**AMENDMENTS TO THE DRAWINGS**

Application No. 10/618,133  
Amdt. mailed December 5, 2005  
Attorney Docket No. ARA-US-P1

ANNOTATED SHEET SHOWING CHANGES

FIG. 3

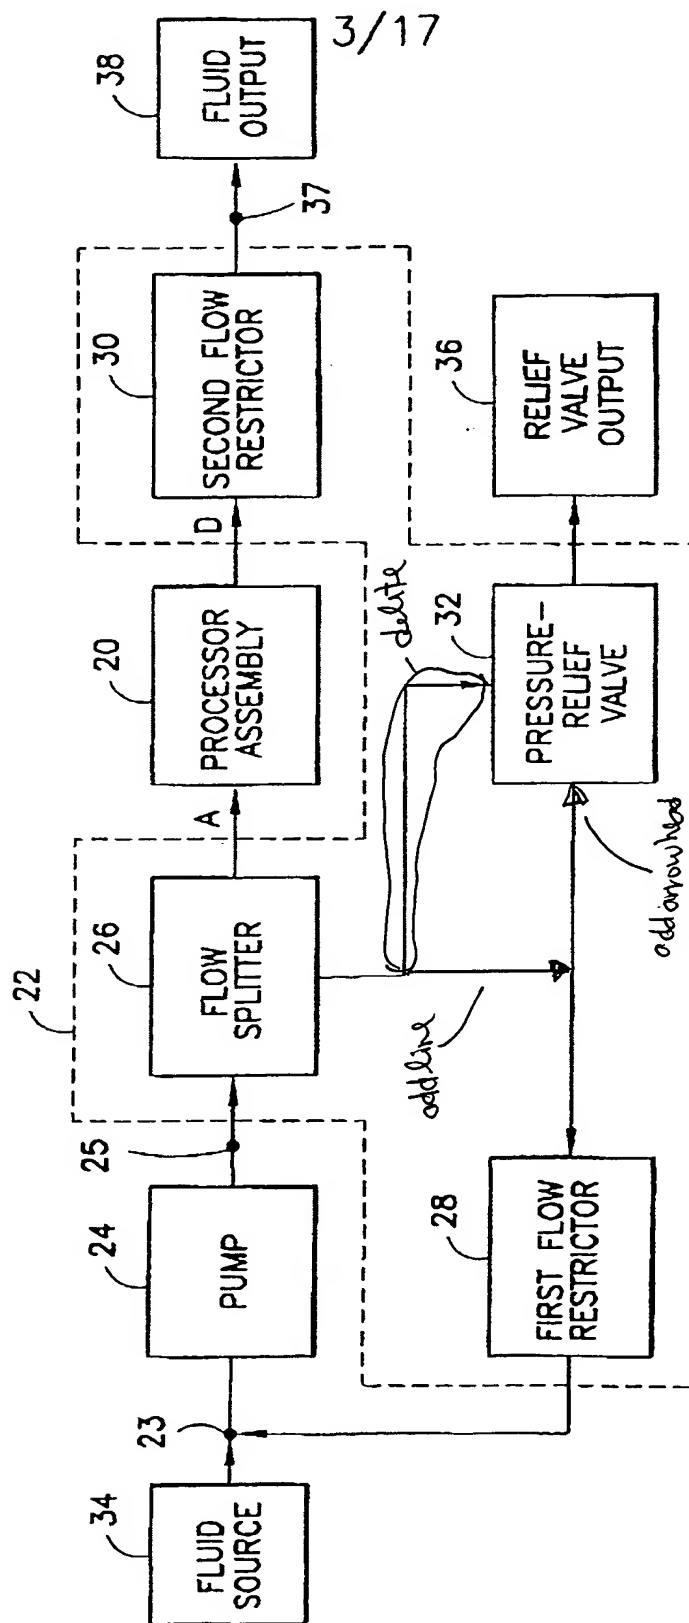
FIG. 3 has been amended to change the positioning of the line leading from the flow splitter 26 to the pressure relief valve 32 and conform FIG. 3 to FIGS. 11A and 13.

FIG. 10A

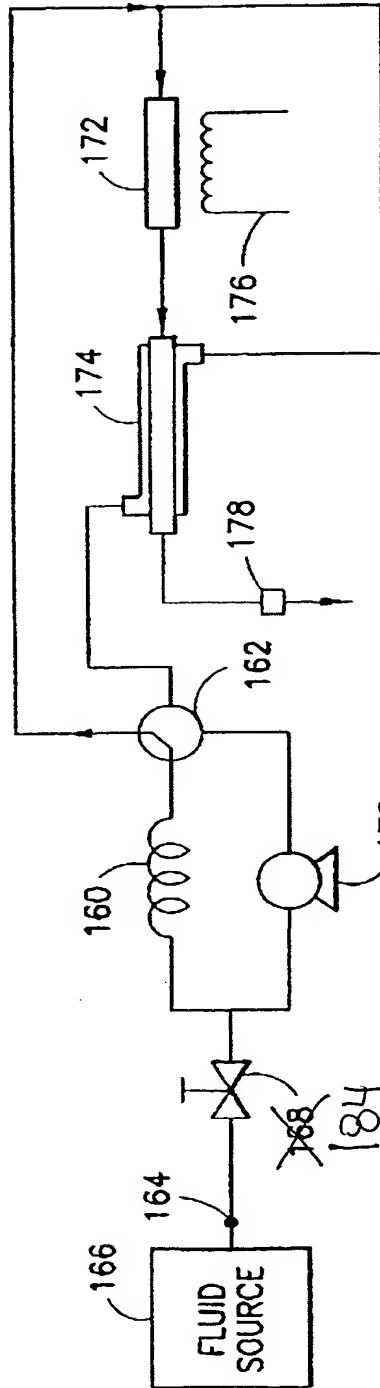
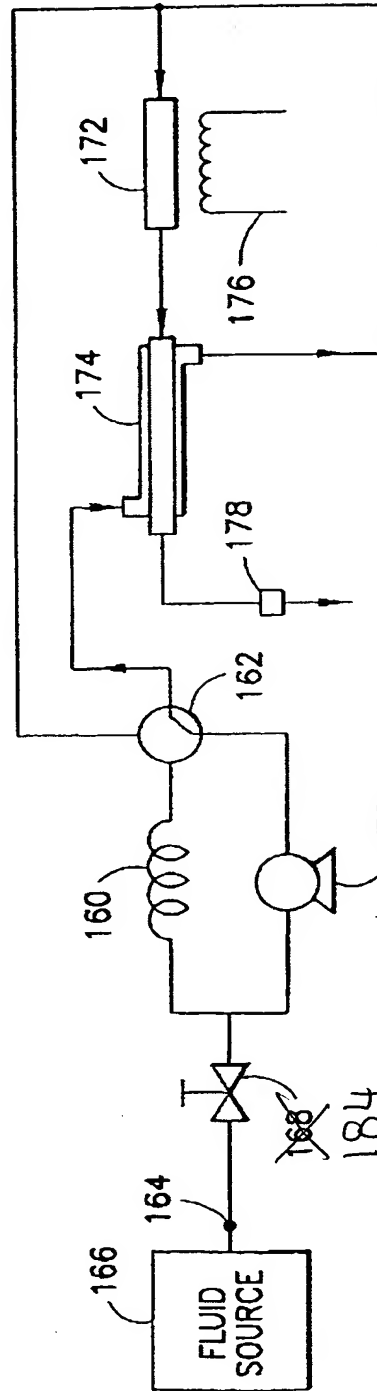
FIGS. 10A and 10B have been amended by changing element number "168" to element number "184" as directed by the Examiner.

Re-number  
168 to 184

Re-number  
168 to 184

FIG.11A

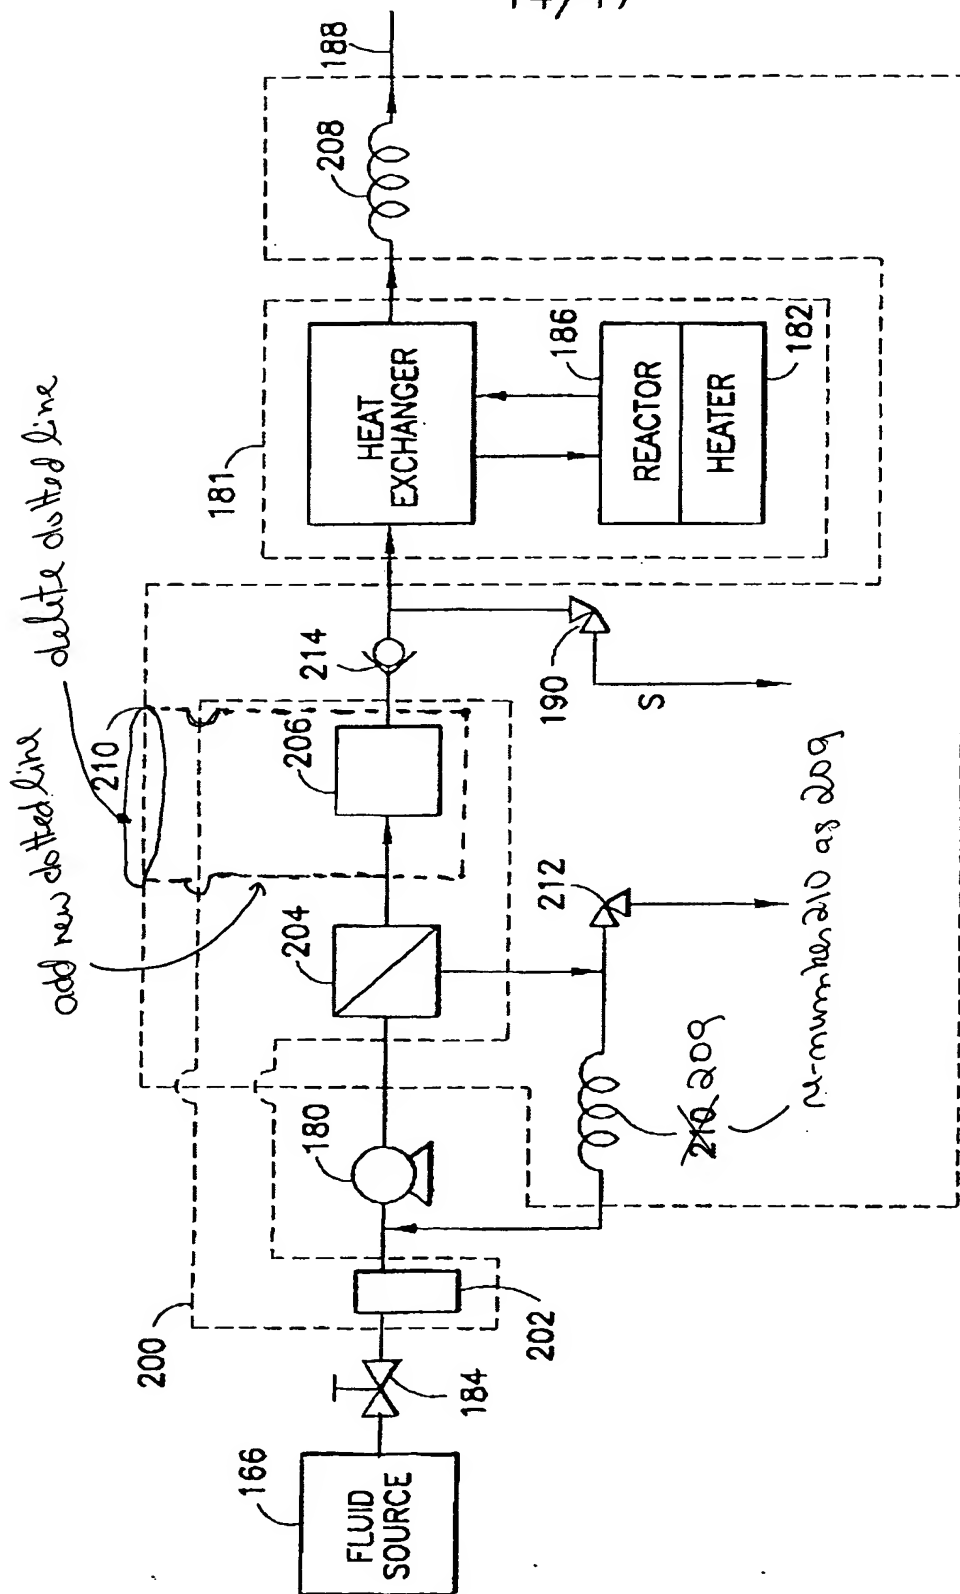
FIG. 11A has been amended to correct drafting errors by deleting the element number 210 having a lead line going to a flow restrictor and renumbering it as element number 209. Also, the dotted line identifying the elements included in element 210 (processor assembly) has been amended to exclude ion exchange device 206. Support for these amendments can be found in the Specification at page 30, line 13 to 24.
